SERVICE LETTER

No. 910

Piper Aircraft Corporation

Engine Oil Quick Drain Valve

SKETCH 1

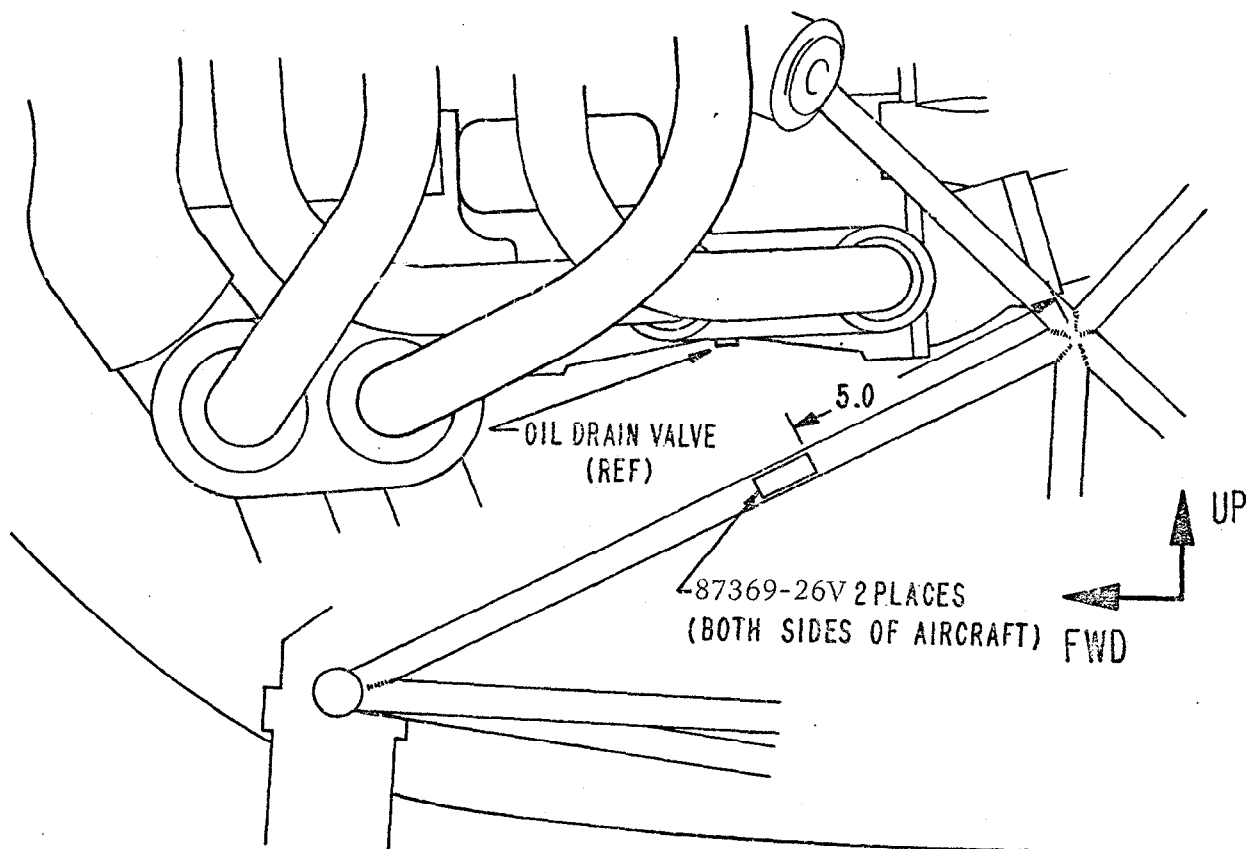
1. Gain access to the lower engine mount (beneath intake and exhaust tubes).
2. Install placard, Piper Part Number 87369-26V, two (2) places, per Sketch 1.
3. Determine if correct oil quick drain valve is installed, refer to Sketch 2.
If incorrect valve is installed, remove incorrect valve and install correct valve, Piper Part Number 492 172V, and safety wire, using .032 safety wire.
4. Re-install items removed in Instruction 1 and make appropriate log book entry of compliance with this Service Release.

Correct Oil Quick Drain Valve

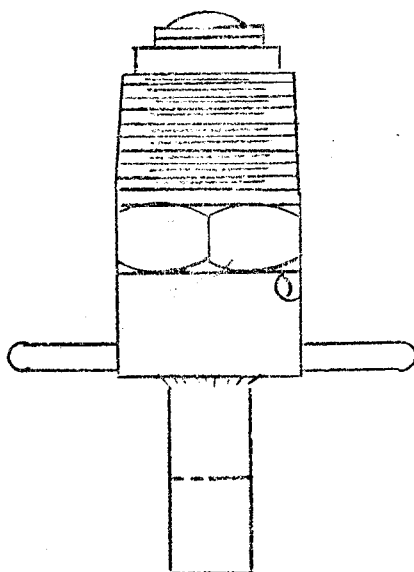
Do Not Use This Oil Quick Drain Valve

On Any PA-28R-200; PA-28R-201; or PA-28RT-201

Oil Quick Drain Valve

Piper Part Number 492 172V
